ADDENDUM NO. 02
LEGRANDE ELEMENTARY SCHOOL ADDITION AND RENOVATION
SCB PROJECT NO. 2210

DATE: August 23, 2023

The purpose of this Addendum is to clarify further the requirements of the plans and specifications. The bidders are governed by the information in this Addendum as if included in the plans and specifications. This Addendum does hereby become a part of the Contract Documents. Each bidder shall acknowledge receipt of this Addendum in the space provided in the Bid Form.

P4.1

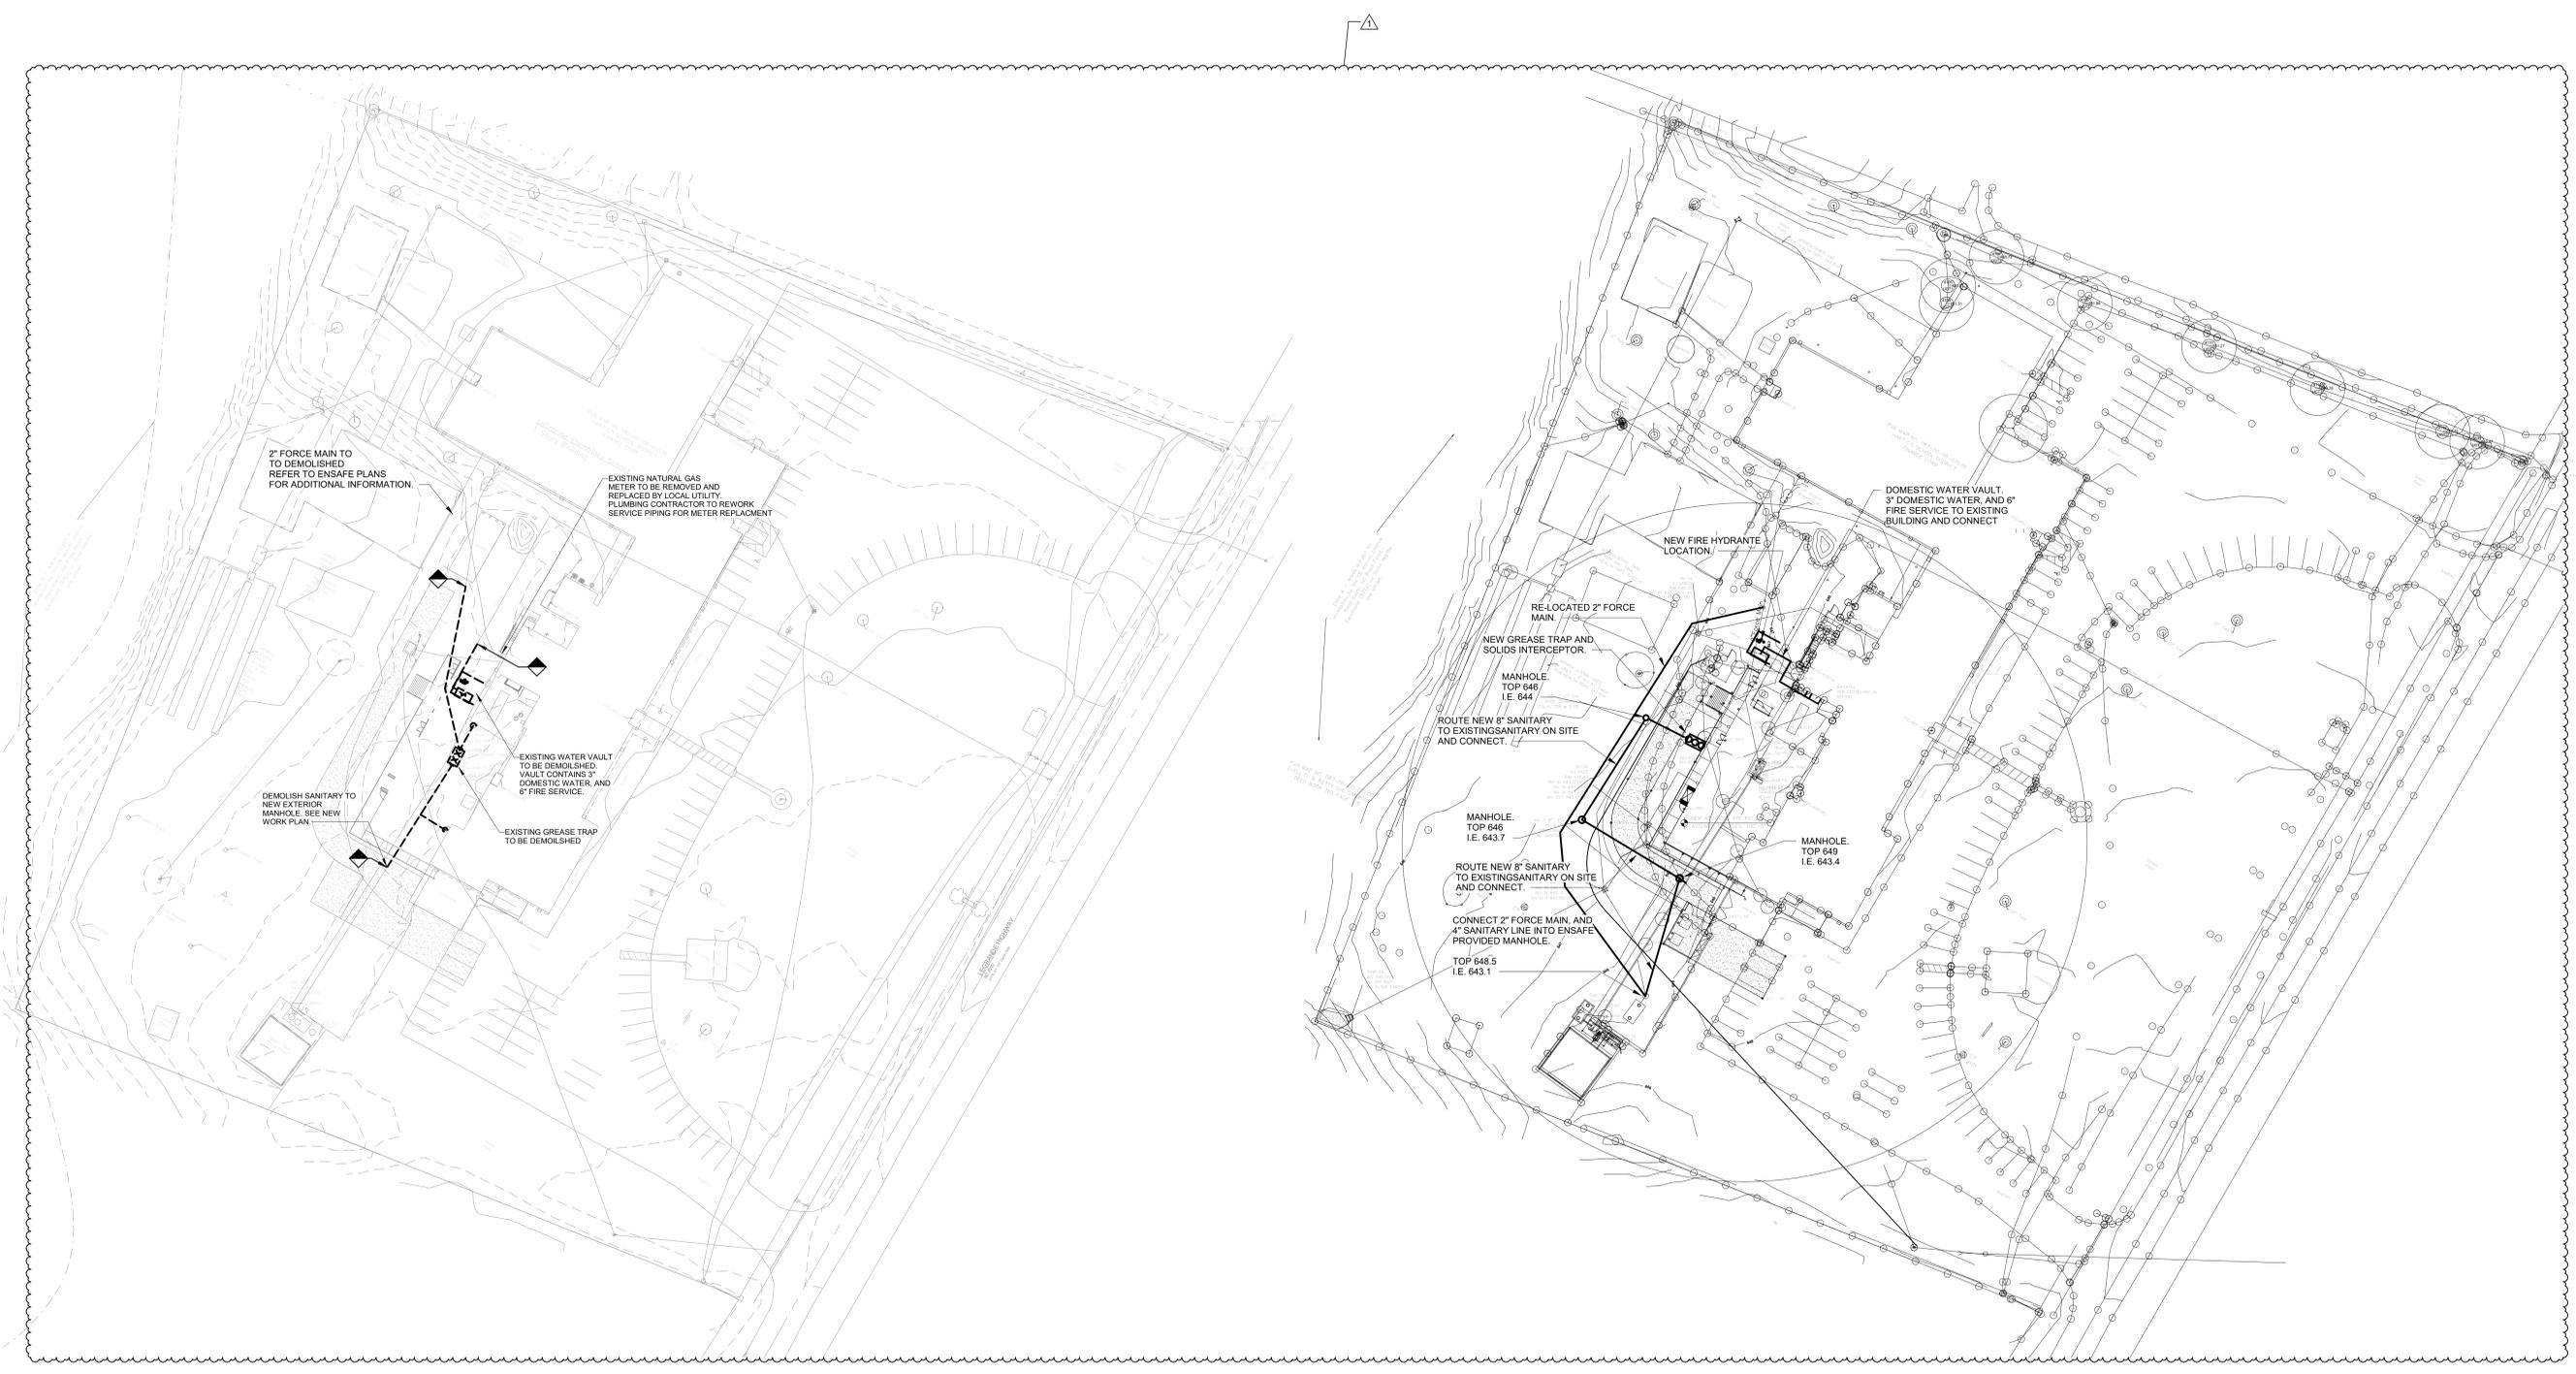
3. Sheet P4.1 – Site Utility Plan – Plumbing
 - a. Reworked all site utility lines per ensafe instruction

1 ROOF PLAN - PLUMBING - OVERALL
NO SCALE

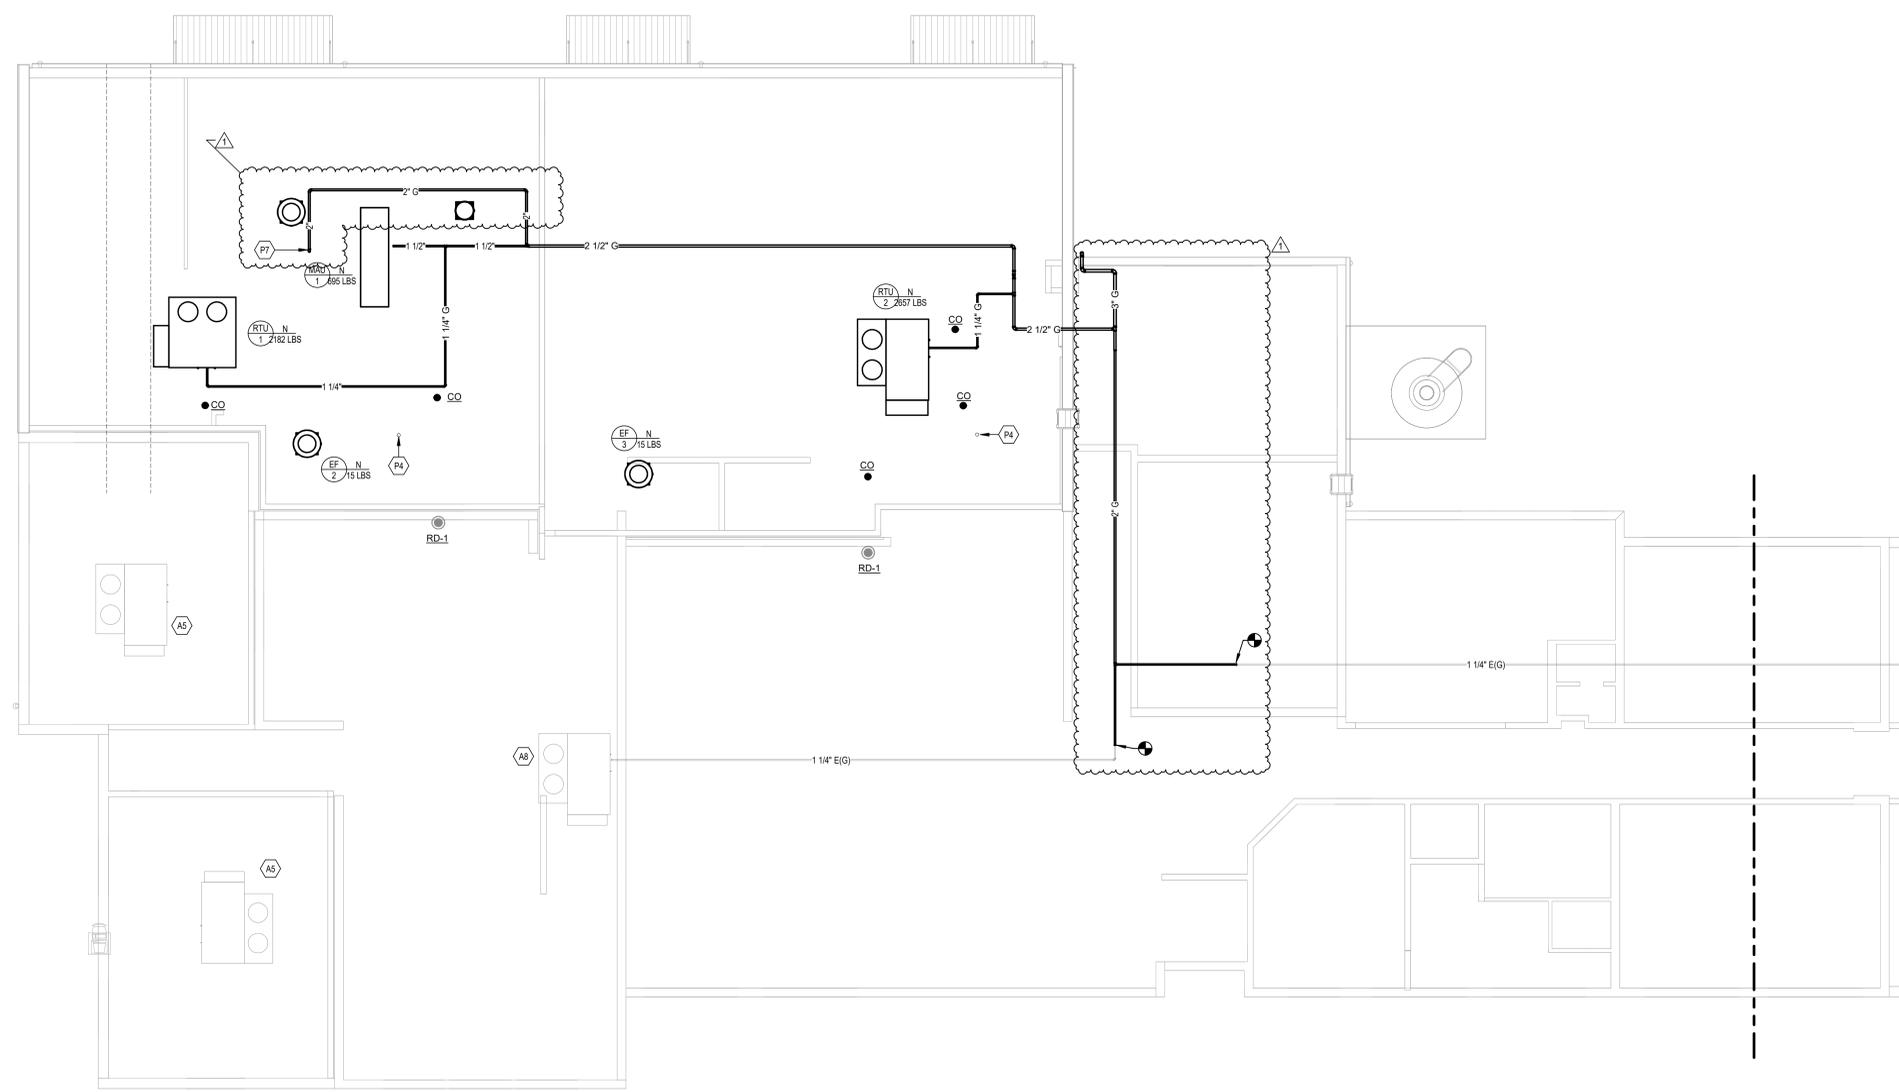
4. Sheet P4.2 – Roof Plan – Plumbing
 - a. Re-worked Natural Gas Line to 3”
 - b. Routed 2-1/2” gas line DN to kitchen equipment.
 - c. Reworked gas to existing rtu's
